REV. B

SAE AS9207

SCREW, MACHINE - STEEL, DIFFUSED NICKEL-CADMIUM PLATED, DOUBLE HEXAGON EXTENDED WASHER HEAD, UNS K14675, 195 KSI MIN, .1640-36 UNJF-3A

FIGURE 1 - SCREW

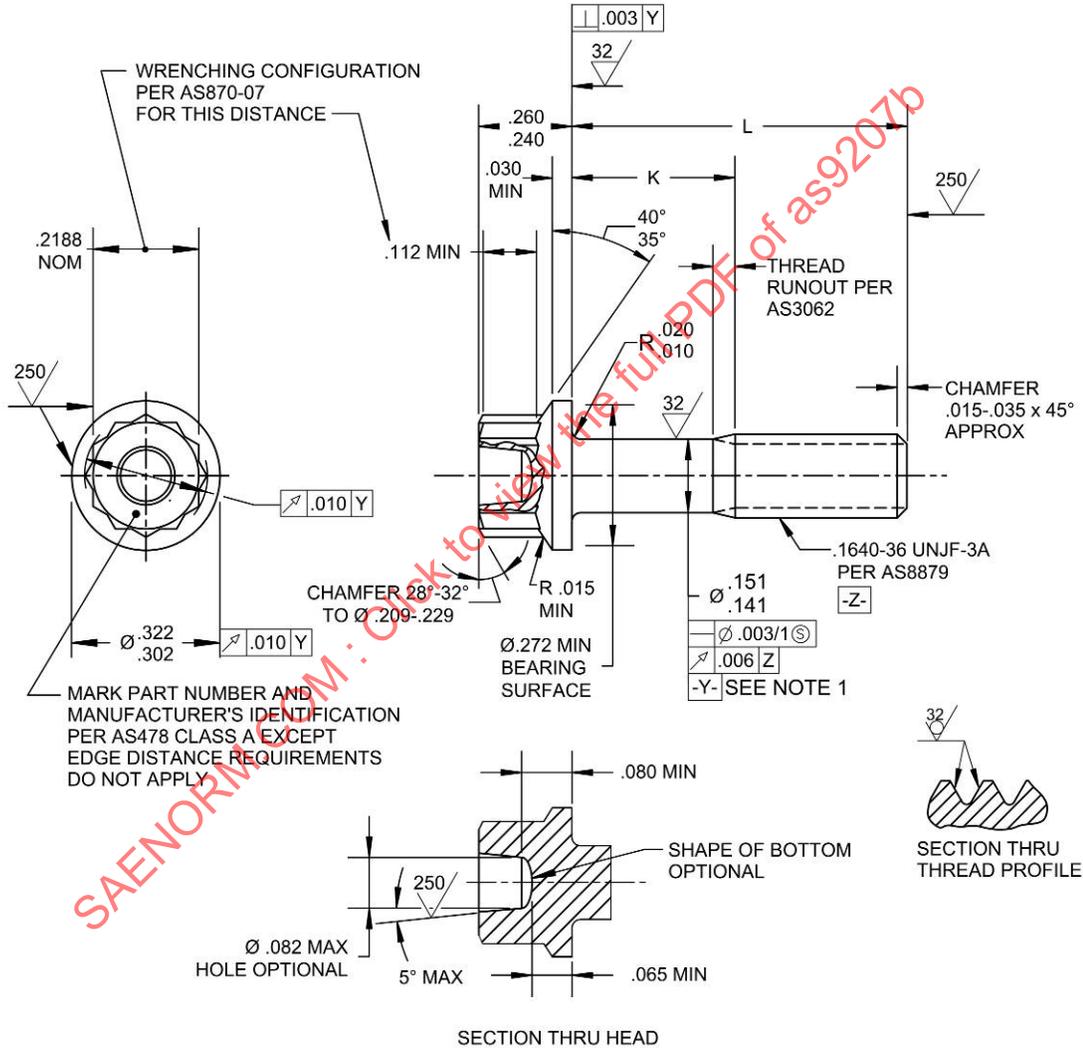
REDRAWN. GENERAL REVISION TO ALLOW OPTIONAL SHAPE AT BOTTOM OF LIGHTENING HOLE, ADD EXCEPTION TO EDGE DISTANCE REQUIREMENTS FOR HEADING MARKING, RELOCATE RUNOUT REQUIREMENT FOR WRENCHING ELEMENT, UPDATE THREAD SPECIFICATION TO AS8879, ADD SURFACE FINISH REQUIREMENT FOR END, ADD AS3062 AND DELETE NOTE ON FILLET FOR INCOMPLETE THREAD REQUIREMENTS, ADD DATUM REQUIREMENTS FOR -.02 THRU -.12 LENGTHS (NEW NOTE 1), AND ADD CADMIUM NOTICE.
